TO: City Council

FROM: Councilor Downs and Councilor Bowman

RE: #26-20, #27-20 Riverside **Flexibility in design of the Grove Street frontage**

Current Design

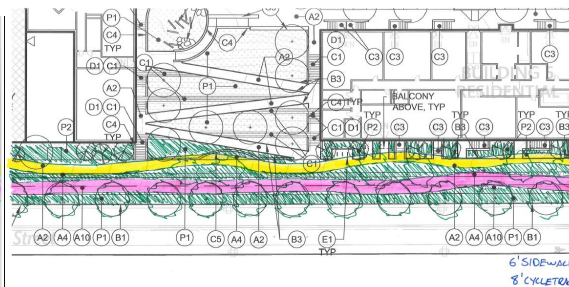
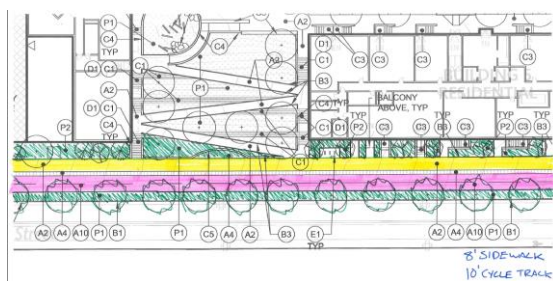
We introduced an amendment to the Council order language before the Oct. 6 Land Use meeting to allow for more flexibility in our conditions for the project frontage along Grove Street. Our concern was, given the amount of pavement between the very wide sidewalk and a wide bike path, the area may look more urban and paved than is appropriate for a scenic route.

1. The condition specifies wider than normal sidewalks. The condition specifies 8 ft. in front of the residences, dropping to 6 feet by the stores and down to 5 1/2 feet close to the restaurant/cafe and entrance to T. We would be less concerned if this was the only pavement required.
2. In addition, the condition specifies a two-way cycle track of 10' for the length of the project. This is a standard width for shared-use paths that serve both cyclists and all other users. But given this is a dedicated bike path, in a location where cyclists should be moving slowly, 8' would be acceptable.

Grove Street Frontage (partial) – As Currently Designed

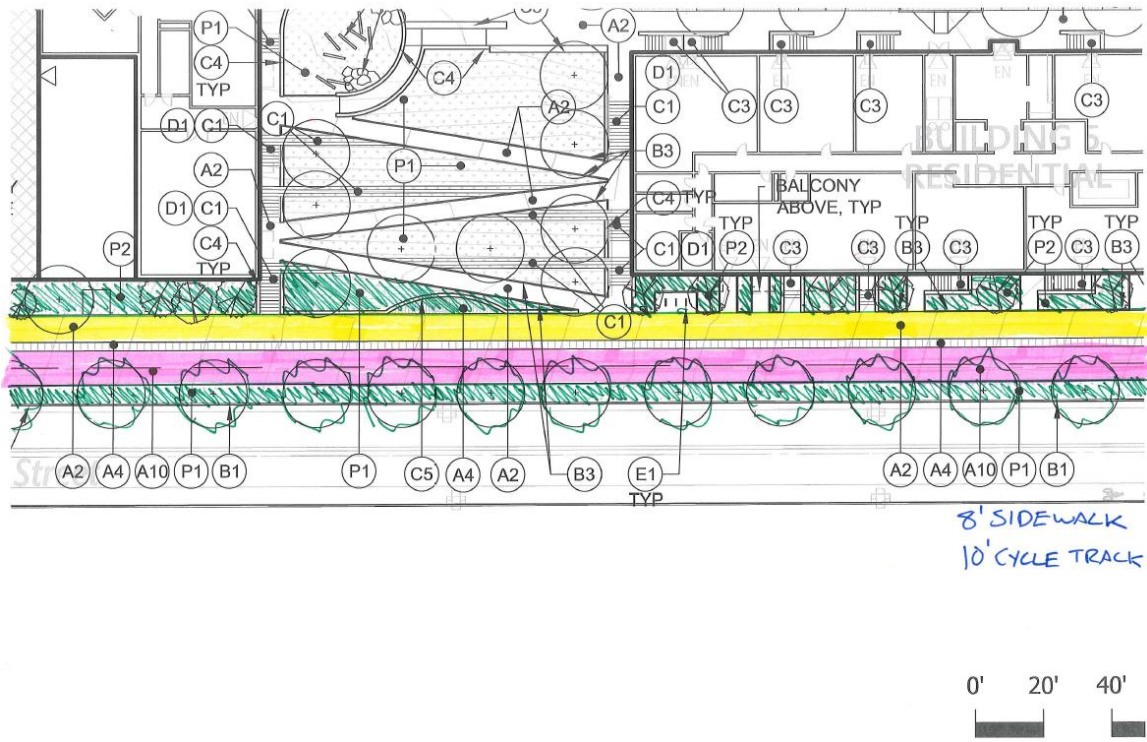
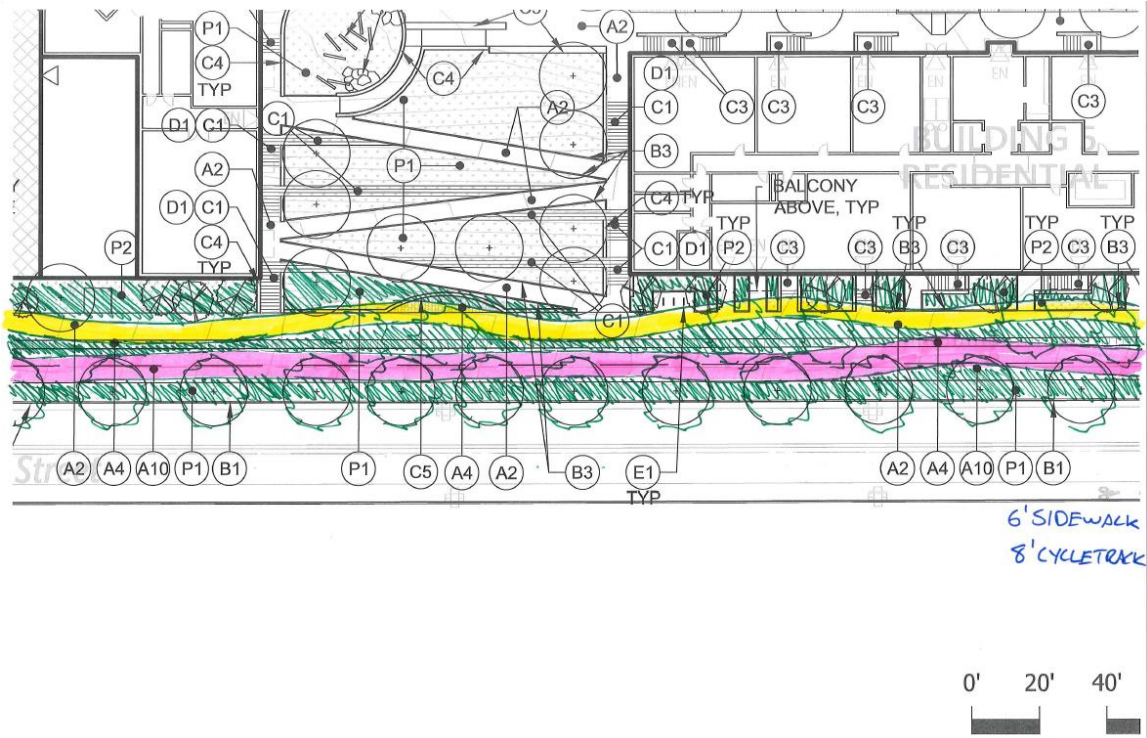
With some flexibility, the extra space created could be used to expand the buffer between the bike lane and sidewalk, thus enabling an amenity zone for benches plantings, trees, art or other things.

Our suggested language gives DPW, Planning and eventually Council via Public Facilities, the final decision on the design, with set minimum widths that are slightly smaller than in the Council order now, but still in keeping with minimums in Newton’s [Street Design Guide](#). We suggest a few criteria for staff to consider. Our amendment does not preclude the design in the current Council Order, but allows for additional consideration for the final design. **Refer to diagrams on next page.**

- iii. A ~~ten-foot wide~~ two-way bicycle track, no less than eight feet in width, along the entire length of the Development Parcel’s Grove Street frontage and continuing from the southerly end of that frontage to the northerly corner of Grove Street and Asheville Road.

- v. A pedestrian walkway, no less than five feet in width, along the entire length of the Development Parcel’s Grove Street frontage and continuing from the southerly end of that frontage to the northerly corner of Grove Street and Asheville Road. ~~which shall be:~~

- vi. A tree way no less than five feet in width throughout its length along the Development Parcel's Grove Street frontage on the easterly side of the two-way bicycle track.

- vii. Light poles in a buffer separating the two-way bicycle track from the pedestrian walkway for the length of the Development Parcel's Grove Street frontage. This buffer shall be at least 2.5 feet wide. All details of the light poles including but not limited to type, height, fixtures, and level of illumination shall be reviewed and approved by the Commissioner of Public Works or his/her designee.

b. The final ~~widths~~ design of the two-way bicycle track described in Condition #14(a)(iii) and the pedestrian walkway described in Condition #14(a)(v) shall be reviewed and approved by the Department of Public Works and the Director of Planning and Development, in consultation with the City's Complete Streets Committee. Such review and approval should take into consideration best practices in design for pedestrian and cyclist safety and usability, accessibility, and environmental sustainability.
